**SUSQUEHANNA STEAM ELECTRIC STATION  
RESPONSE TO REQUEST FOR ADDITIONAL  
INFORMATION ON PROPOSED RELIEF  
REQUEST NO. 3RR-18 TO THE THIRD 10-YEAR  
INSERVICE INSPECTION PROGRAM  
FOR SUSQUEHANNA SES UNIT 2  
PLA-6810**

**Docket No. 50-388**

**Layout drawing, Reactor Vessel Shell  
Unit 1 and 2**

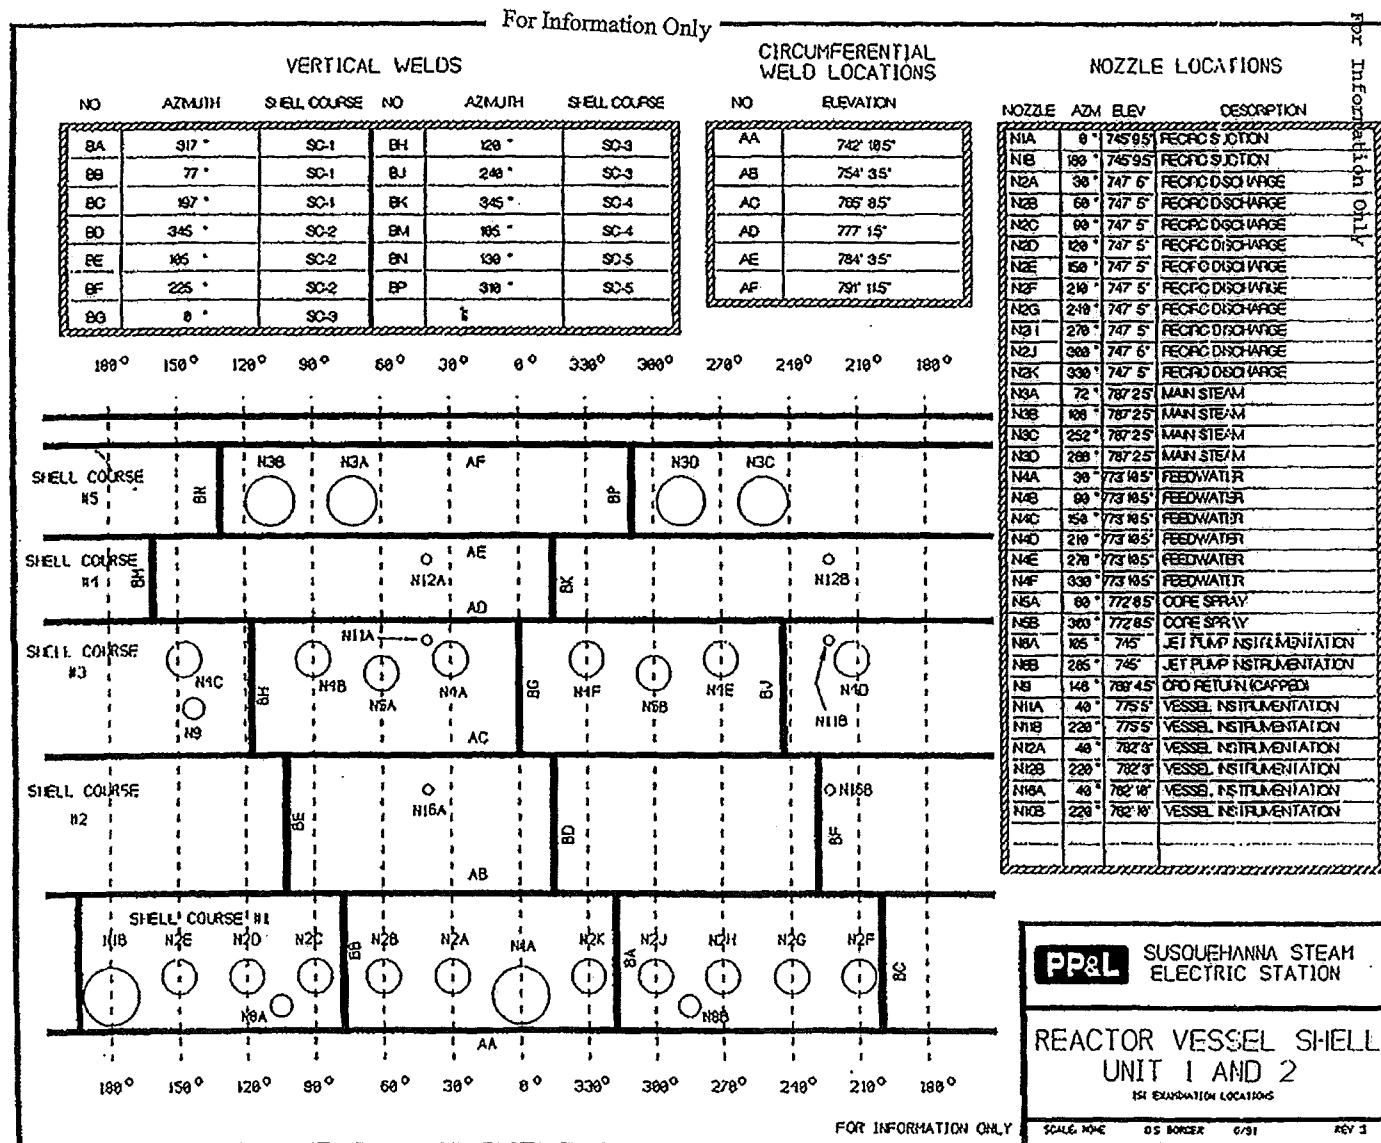
Provide a complete description of the subject weld (inspection category and item no.), the materials of construction, and its location in the system.

The AF weld is classified as an ASME Section XI Category/Item B-A/B1.30 weld. One third of this weld is volumetrically examined every inspection period. This weld connects Shell Course 5 (external reactor vessel) to the Shell Closure Flange. The weld is located at elevation 791', 115" (59'-7 19/32" from vessel zero). Per PPL Susquehanna FSAR, Rev 62, Table 5.2-4, the Shell Closure Flange is a Forge Ring made of Low Alloy Steel, SFA-508, Cl.2. The weld also consists of low alloy steel, SFA-5.5.
